Snowy 2.0 Transmission Connection, Application Number SSI 9717

Visual Impact Management Plan

7 August 2023

Rev 13

Figure 5-4: Lobs Hole Ravine Transmission Towers as Identified with the Supplementary Landscape and Visual Impact Assessment Rev 01. Image Source: Supplementary Landscape and Visual Impact Assessment Rev 01.

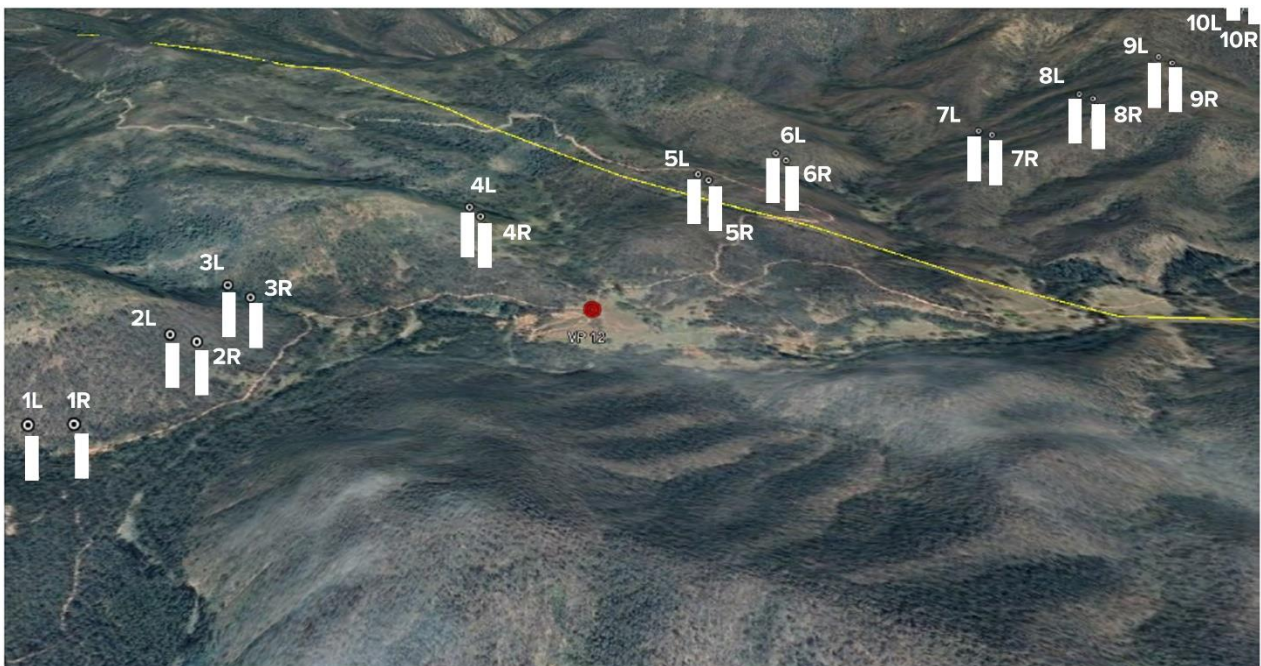
15.	Need to clearly state which structures are circled in figure 6 to be painted green to ensure consistency with Table 5.p13	Image caption amended to make clear which towers are painted
